**BOARD OF COUNTY COMMISSIONERS  
ORANGE COUNTY, FLORIDA**

**ADDENDUM NO. 3 / IFB NO. Y18-729-TA**

**SOUTH WATER RECLAMATION FACILITY INFLUENT PUMP STATION  
IMPROVEMENTS**

SECTION 3  
3/8"=1'-0"

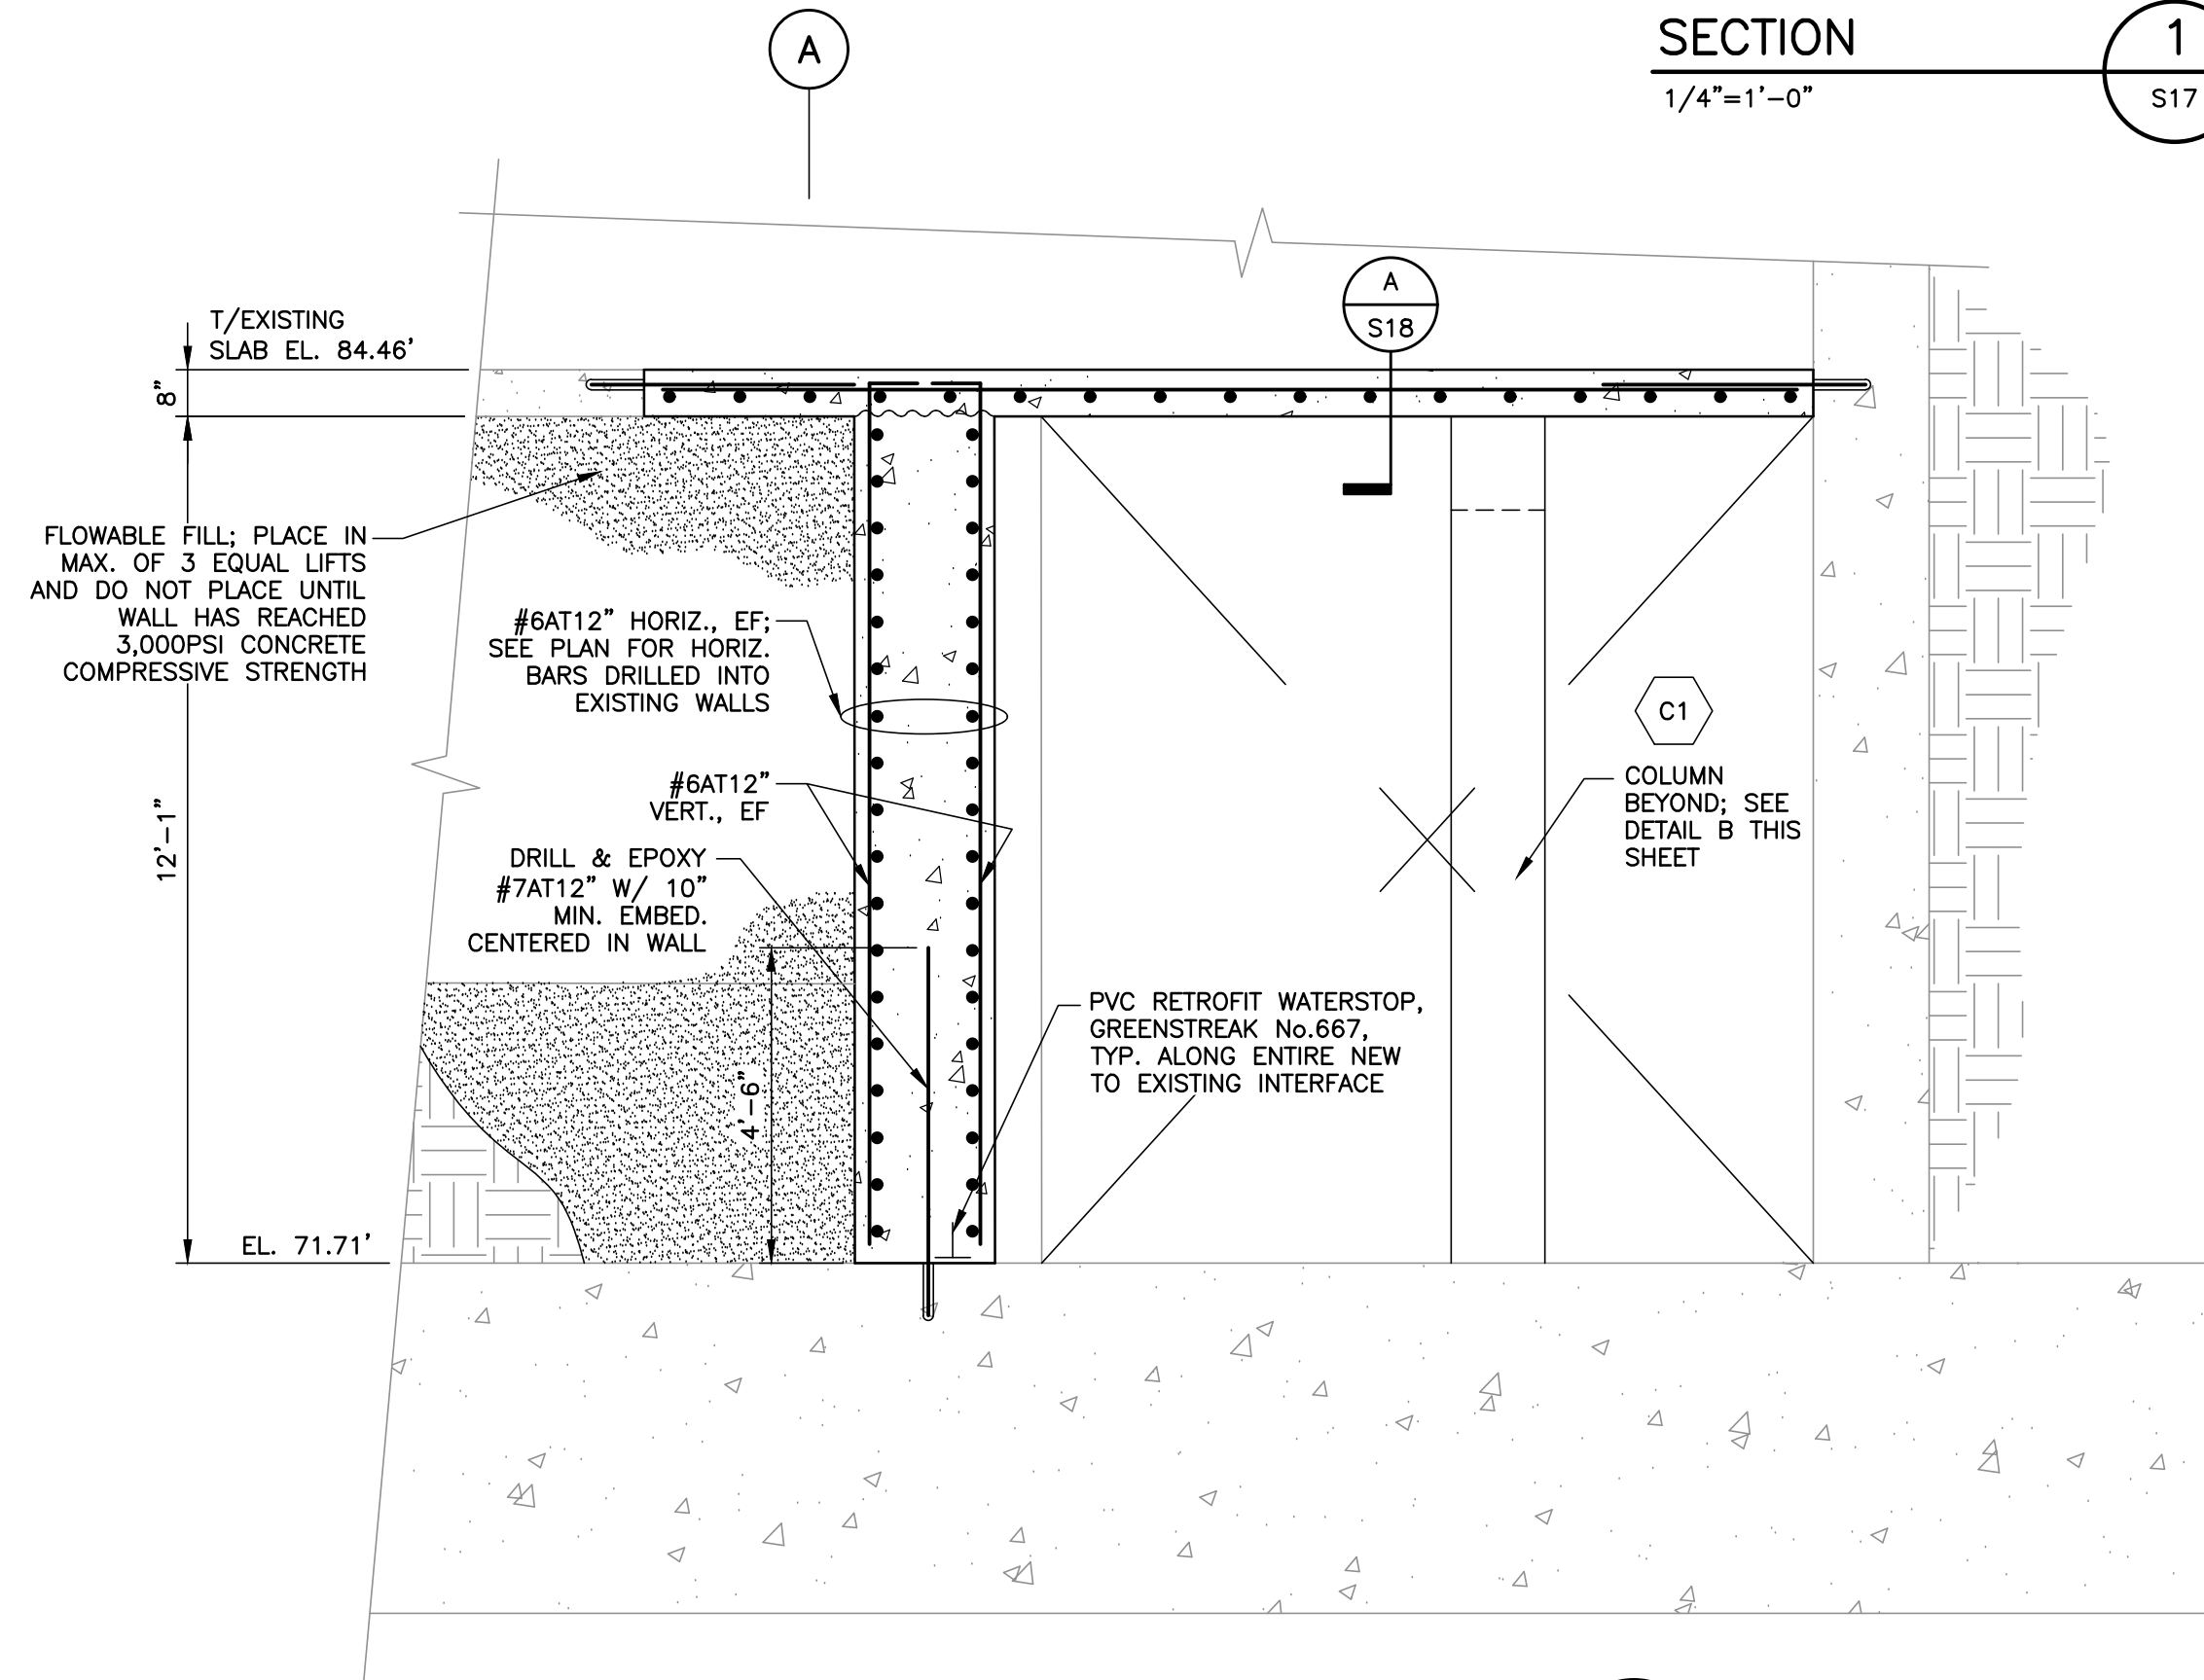
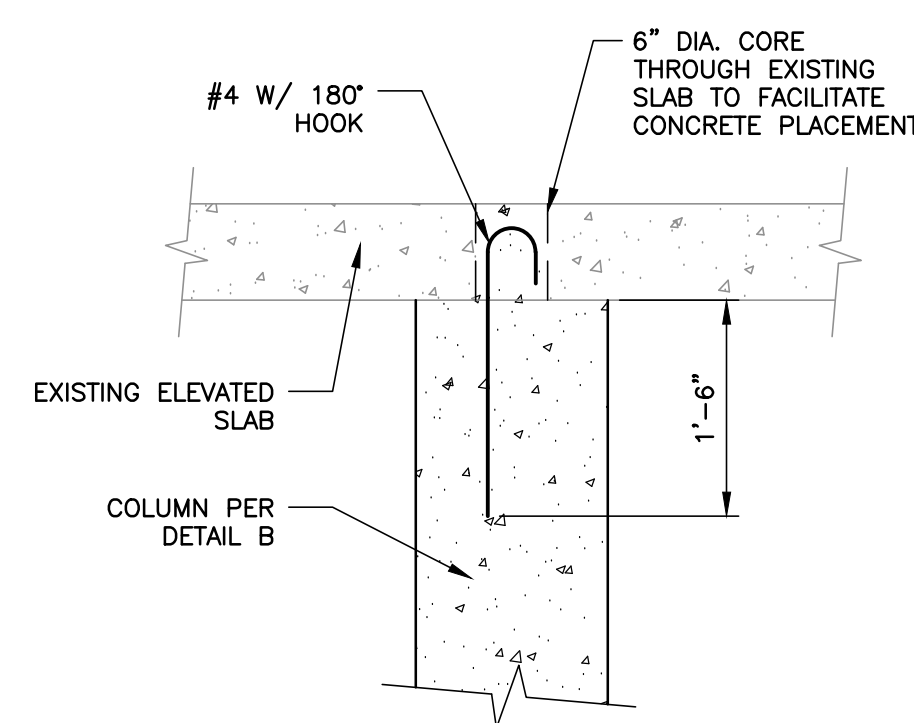
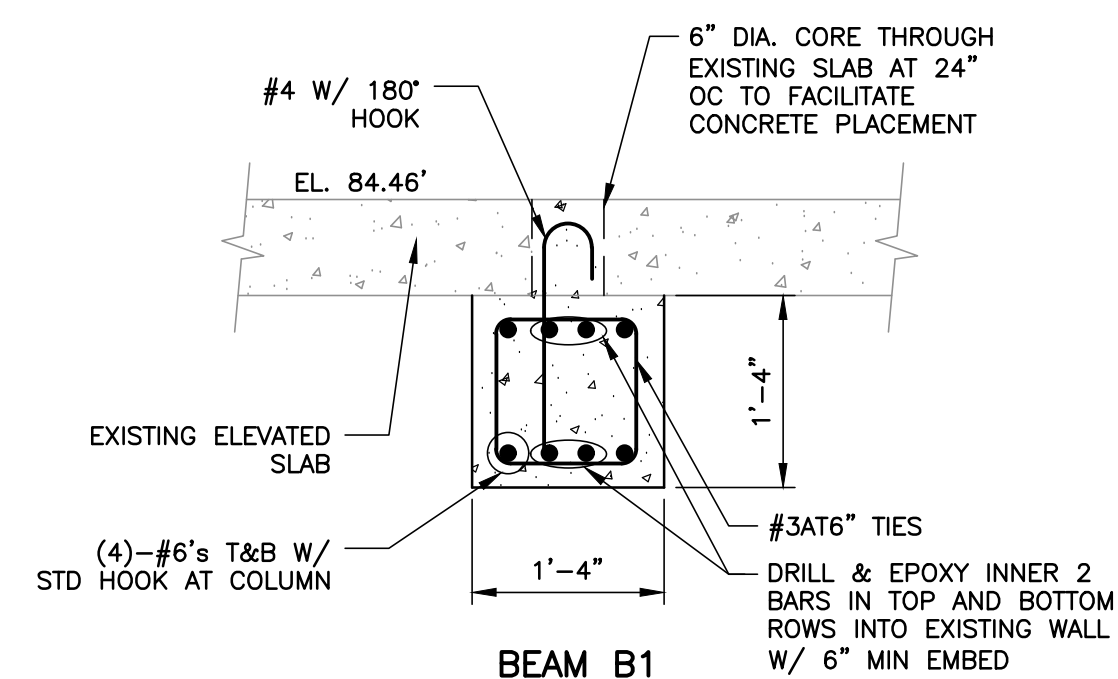
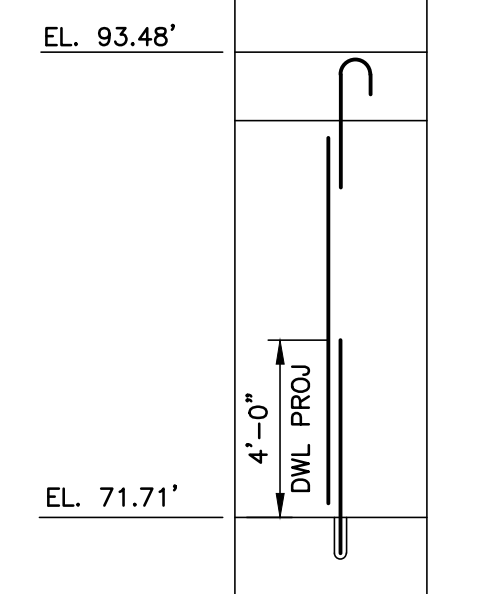
4. Drawing S18 be deleted in its entirety and replaced with the attached Revised S18 drawing.
5. Drawing M06 – Delete note 2 in its entirety and replace with “2. PIPES THROUGH CONCRETE WALLS PER PIPE PENETRATION DETAIL C ON SHEET M-17.”
6. Drawing M07 to be deleted in its entirety and replaced with the attached Revised M07 drawing.
7. Drawing M08 to be deleted in its entirety and replaced with the attached Revised M08 drawing.
8. Drawing M09 be deleted in its entirety and replaced with the attached Revised M09 drawing.
9. Drawing M15 be deleted in its entirety and replaced with the attached Revised M15 drawing.
10. Drawing M16 to be deleted in its entirety and replaced with the attached Revised M16 drawing.

OCU FILE NO.: OCU #	SCALE: NOTED
DESIGNED BY: SC	DRAWING NO.:
DRAWN BY: CMR/DHG	M09
CHECKED BY: MDP	SHEET: 73 OF 123
CADD FILE: M09.DWG

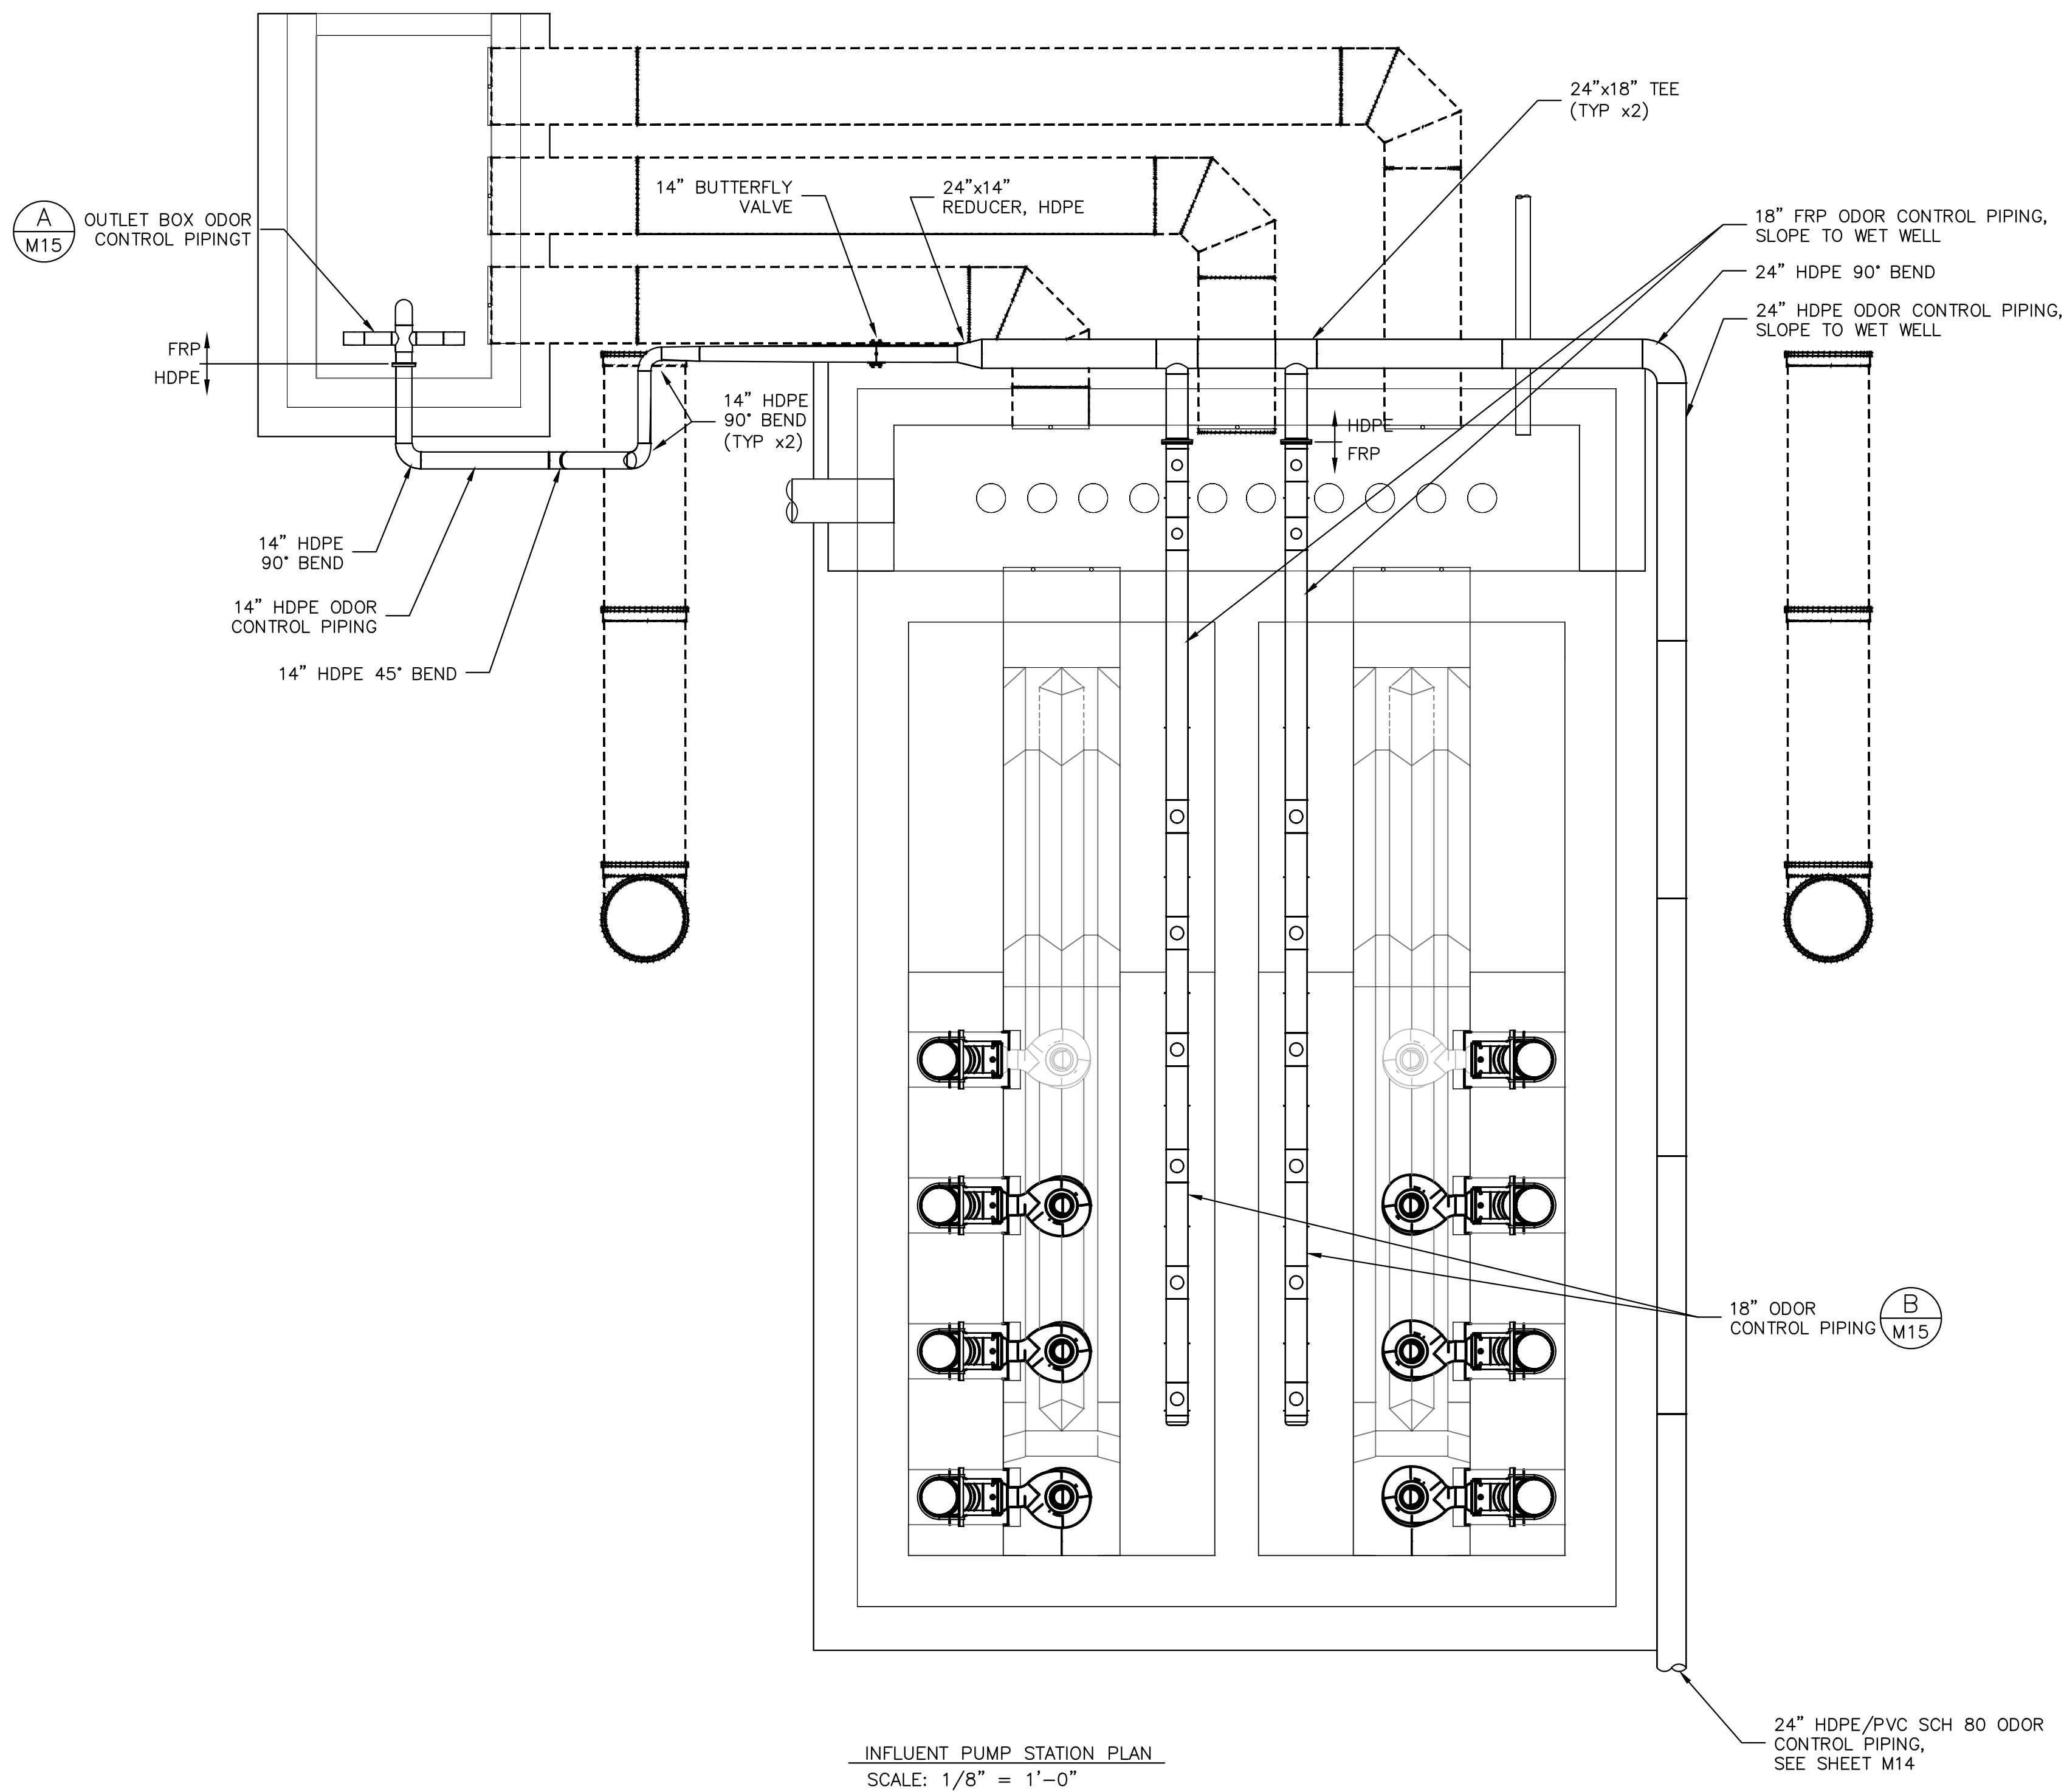
**24. Q. Detail ‘D’ on M17 shows stainless steel anti-rotation baffle. However, we cannot determine where this detail applies. Please advise.**

- 33. Q. Drawing M-09 has a note to provide “Tap blind flange near bottom with 2” steel pipe and 2” plug valve. Drain to wetwell (Type x2)” Is this required to have a hard pipe connection to the wetwell? If so, what is the discharge elevation?**

A. Drawing M09 shows location of anti-rotation baffle.

A. Drawing M-09 has been revised to clarify construction requirements and is included in Section C of this addendum.
